**COUNTY OF VENTURA
PUBLIC WORKS AGENCY**

Subject: CONTRACT CHANGE ORDER NO. 1
APPROVAL REQUESTED
Pavement Resurfacing – Guiberson Rd, Riverside Ave, and Sespe St
Project No. 50631 Spec No. RD23-02
Contractor: J&H Engineering General Contractors, Inc.

1.0 Add New Contract Item: Culvert Replacement at Milepost 5.97

CHANGE ORDER NO. 1
EXHIBIT 'A'

PIPE CULVERT PLAN VIEW AT MP 5.91
SCALE = 1" = 10'

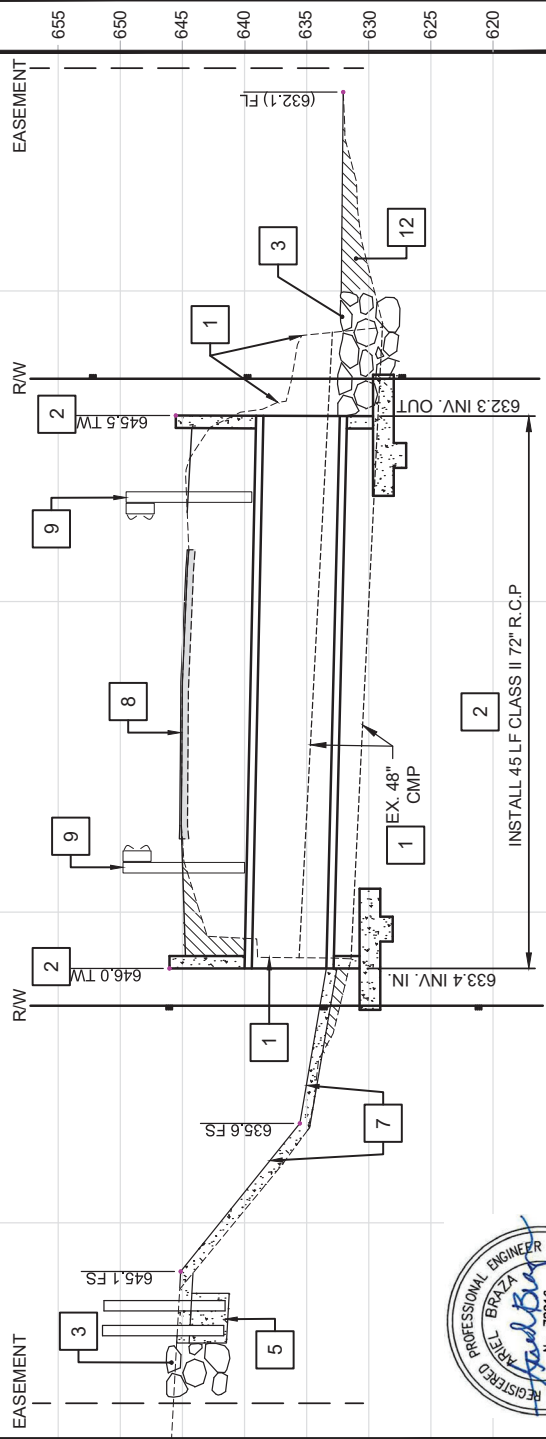
- 1 SAWCUT AND REMOVE EXISTING PAVEMENT, HEADWALLS, CULVERTS, GUARDRAIL, POSTS AND EXCESS MATERIAL.
- 2 INSTALL CLASS II 72" R.C.P. CULVERT AND HEADWALL. CONSTRUCT PIPE CULVERT HEADWALL PER CALTRANS STD. PLAN RSP D90. H=PER PLAN. SEE CULVERT PLAN HEREON. SEE CULVERT PROFILE AND DETAILS SHOWN ON SHEET 4B FOR MORE INFORMATION.

- 3 CONSTRUCT 1-TON RIP-RAP WITH SYNTHETIC FILTER FABRIC, 20' L x 10' W x 4.25' D (DOWNSTREAM) AND 4' W x 4.25' D (ADJACENT TO BOLLARD FOOTING UPSTREAM).

- 4 PLACE OBJECT MARKER TYPE L-1(CA) WITH MILEPOST MARKING PER OBJECT MARKER DETAIL SHOWN ON SHEET 4D.
- 5 INSTALL CONCRETE BOLLARDS AND BOLLARD FOOTING PER DEBRIS BARRIER DETAIL SHOWN ON SHEET 4C. CONTRACTOR SHALL FORM BOLLARD CONCRETE FOOTING WITH 90% OF MAXIMUM DENSITY COMPACTION UNDER FOOTING & BACKFILL. BOLLARDS SHALL BE 10 FOOT LONG, WITH 7 FOOT ABOVE THE TOP OF CONCRETE FOOTING. 6" DIAMETER, SCHEDULE 40 STEEL PIPE, SET 5'-0" O.C. BOLLARDS SHALL BE PLACED IN TWO STAGGERED ROWS 2'-0" O.C. A PART. BOLLARDS SHALL BE FILLED SOLID WITH CONCRETE. OUTSIDE OF BOLLARDS SHALL BE KEPT CLEAN.

- 7 CONSTRUCT 10" THICK REINFORCED CONCRETE APRON AT R.C.P. INLET. SEE SECTIONS A-A AND B-B ON SHEET 4C (646.0) EX FOR MORE DETAILS. APRON MAY BE FORMED OR SHOTCRETE, PER SPECIFICATIONS.

- 8 FOR CULVERT TRENCH BACKFILL SEE TRENCHING DETAILS SHOWN ON SHEET 4D.
- 9 INSTALL FLARED TERMINAL SYSTEM END TREATMENT TYPE SRT-350 PER CALTRANS STD. PLAN RSP A77P1, TYPE 11B WITH STEEL POSTS PER STD. PLAN A77N2. INSTALL GUARDRAIL BUTTERFLY REFLECTORS @ 12.5 FEET INTERVALS.

- 10 INSTALL IN-LINE TERMINAL SYSTEM END TREATMENT TYPE SKT-350 PER CALTRANS STD. PLAN RSP A77P1, TYPE 11A WITH STEEL POSTS PER STD. PLAN A77N2. INSTALL GUARDRAIL BUTTERFLY REFLECTORS @ 12.5 FEET INTERVALS.

- 11 INSTALL 2' WIDE CONCRETE SWALE PER DETAIL SHOWN ON SHEET 4D.
- 12 PLACE ±2' DEPTH OF NATIVE SOIL COMPACT TO 90% COMPACTION. MAINTAIN POSITIVE FLOW DOWNSTREAM.

PIPE CULVERT PROFILE AT MP 5.91

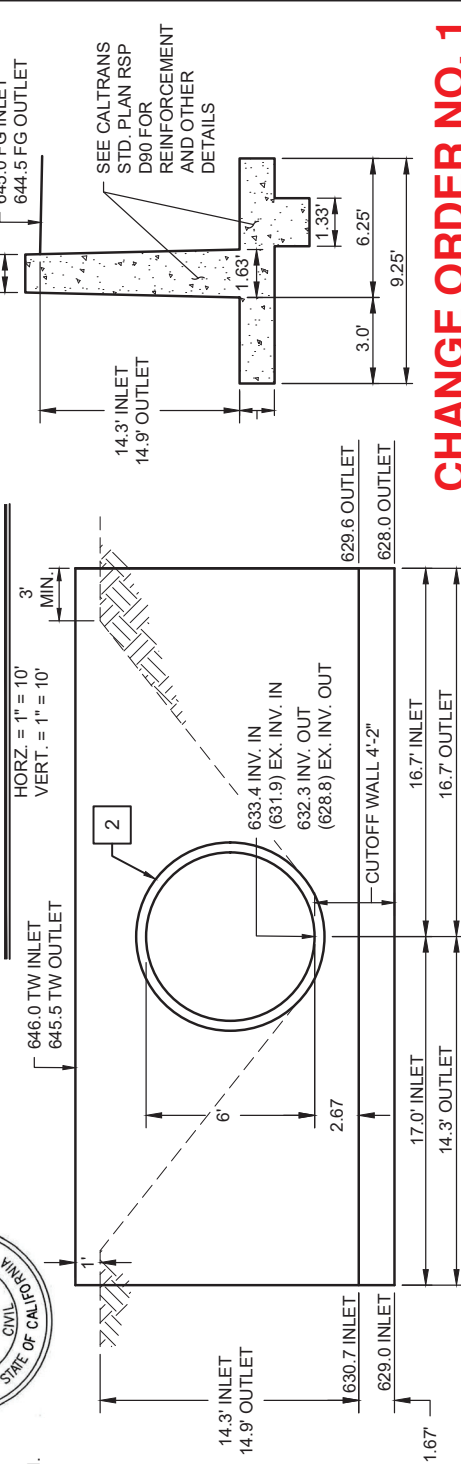
- 1 SAWCUT AND REMOVE EXISTING PAVEMENT, HEADWALLS, CULVERTS, GUARDRAIL, POSTS AND EXCESS MATERIAL.
- 2 INSTALL CLASS II 72" R.C.P. CULVERT AND HEADWALL. CONSTRUCT PIPE CULVERT HEADWALL PER CALTRANS STD. PLAN RSP D90. H=PER PLAN. SEE CULVERT PLAN ON SHEET 4A. SEE CULVERT PROFILE AND DETAILS HEREON.

- 3 CONSTRUCT 1-TON RIP-RAP WITH SYNTHETIC FILTER FABRIC, 20' L X 10' W X 4.25' D (DOWNSTREAM) AND 4' W X 4.25' D (ADJACENT TO BOLLARD FOOTING UPSTREAM).

- 5 INSTALL CONCRETE BOLLARDS AND BOLLARD FOOTING PER DEBRIS BARRIER DETAIL SHOWN ON SHEET 4C. CONTRACTOR SHALL FORM BOLLARD CONCRETE FOOTING WITH 90% OF MAXIMUM DENSITY COMPACTION UNDER FOOTING & BACKFILL. BOLLARDS SHALL BE 10 FOOT LONG, WITH 7 FOOT ABOVE THE TOP OF CONCRETE FOOTING, 6" DIAMETER, SCHEDULE 40 STEEL PIPE, SET 5'-0" O.C. BOLLARDS SHALL BE PLACED IN TWO STAGGERED ROWS 2'-0" O.C. A PART. BOLLARDS SHALL BE FILLED SOLID WITH CONCRETE. OUTSIDE OF BOLLARDS SHALL BE KEPT CLEAN.

- 7 CONSTRUCT 10" THICK REINFORCED CONCRETE APRON AT R.C.P. INLET. SEE SECTIONS A-A AND B-B ON SHEET 4C FOR MORE DETAILS. APRON MAY BE FORMED OR SHOTCRETE, PER SPECIFICATIONS.

- 8 FOR CULVERT TRENCH BACKFILL SEE TRENCHING DETAILS SHOWN ON SHEET 4D.
- 9 INSTALL FLARED TERMINAL SYSTEM END TREATMENT TYPE SRT-350 PER CALTRANS STD. PLAN RSP A77P1, TYPE 11B WITH STEEL POSTS PER STD. PLAN A77N2. INSTALL GUARDRAIL BUTTERFLY REFLECTORS @ 12.5 FEET INTERVALS.

- 12 PLACE ±2' DEPTH OF NATIVE SOIL COMPACT TO 90% COMPACTION. MAINTAIN POSITIVE FLOW DOWNSTREAM

DESIGNED _____ AB/JP	SPEC. NO. RD23-02	PAVEMENT RESURFACING	SHEET 4C
DRAWN _____ JH	PROJ. NO. 50631	GUIBERSON ROAD, RIVERSIDE AVENUE, SESPE STREET	OF 4
CHECKED _____ CH		GUIBERSON ROAD CULVERT REPLACEMENT AT MP 5.97	DRAWING NO. 116505C
APPROVED _____ CH

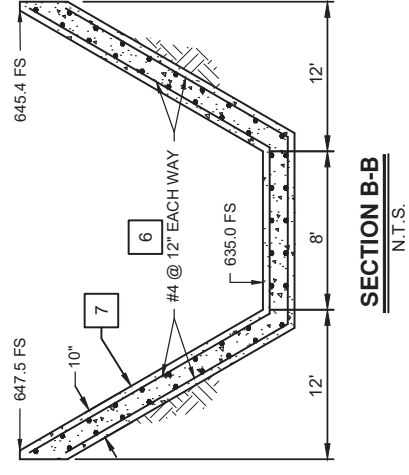
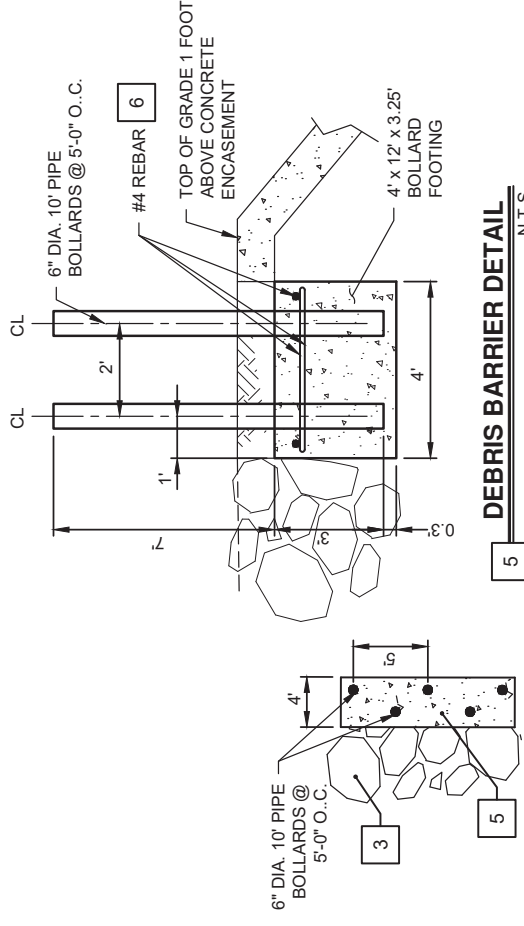
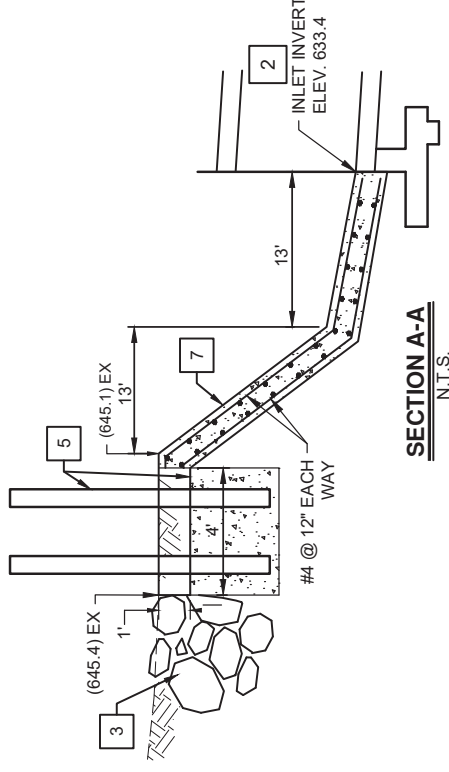
- 2 INSTALL CLASS II 72" R.C.P. CULVERT AND HEADWALL. CONSTRUCT PIPE CULVERT HEADWALL PER CAL TRANS STD. PLAN RSP D90. H=PER PLAN. SEE CULVERT PLAN ON SHEET 4A. SEE CULVERT PROFILE AND DETAILS SHOWN ON SHEET 4B FOR MORE INFORMATION.

- 3 CONSTRUCT 1-TON RIP-RAP WITH SYNTHETIC FILTER FABRIC, 20' L X 10' W X 4.25' D (DOWNSTREAM) AND 4' W X 4.25' D (ADJACENT TO BOLLARD FOOTING UPSTREAM).

- 5 INSTALL CONCRETE BOLLARDS AND BOLLARD FOOTING PER DEBRIS BARRIER DETAIL SHOWN HEREON. CONTRACTOR SHALL FORM BOLLARD CONCRETE FOOTING WITH 90% OF MAXIMUM DENSITY COMPACTION UNDER FOOTING & BACKFILL. BOLLARDS SHALL BE 10 FOOT LONG, WITH 7 FOOT ABOVE THE TOP OF CONCRETE FOOTING. 6" DIA. SCHEDULE 40 STEEL PIPE, SET 5'-0" O.C. BOLLARDS SHALL BE PLACED IN TWO STAGGERED ROWS 2'-0" O.C. A PART, BOLLARDS SHALL BE FILLED SOLID WITH CONCRETE. OUTSIDE OF BOLLARDS SHALL BE KEPT CLEAN.

- 6 #4 REBAR SHALL HAVE 2" CONCRETE COVER.
- 7 CONSTRUCT 10" THICK REINFORCED CONCRETE APRON AT R.C.P. INLET. SEE SECTIONS A-A AND B-B HEREON. APRON MAY BE FORMED OR SHOTCRETE, PER SPECIFICATIONS.

SHEET 4D
OF 4
DRAWING NO. 116505D

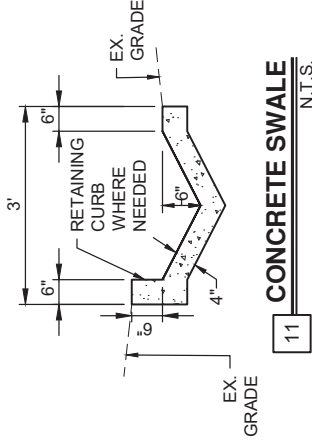
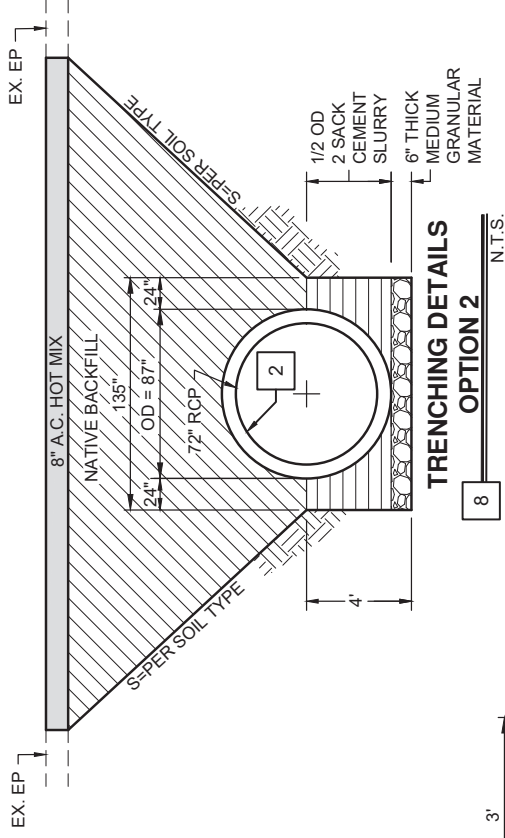
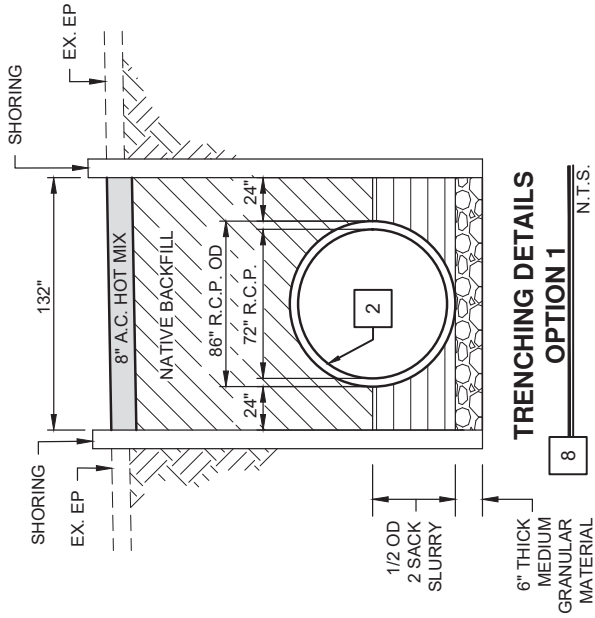
2 INSTALL CLASS II 72" R.C.P. CULVERT AND HEADWALL. CONSTRUCT PIPE CULVERT HEADWALL PER CALTRANS STD. PLAN RSP D90. H-PER PLAN. SEE CULVERT PLAN ON SHEET 4A. SEE CULVERT PROFILE AND DETAILS SHOWN ON SHEET 4B FOR MORE INFORMATION.

4 PLACE OBJECT MARKER TYPE L-1(CA) WITH MILEPOST MARKING PER OBJECT MARKER DETAIL SHOWN HEREON.

8 FOR CULVERT TRENCH BACKFILL SEE TRENCHING DETAILS SHOWN HEREON.

11 INSTALL 2' WIDE CONCRETE SWALE PER DETAIL SHOWN HEREON.
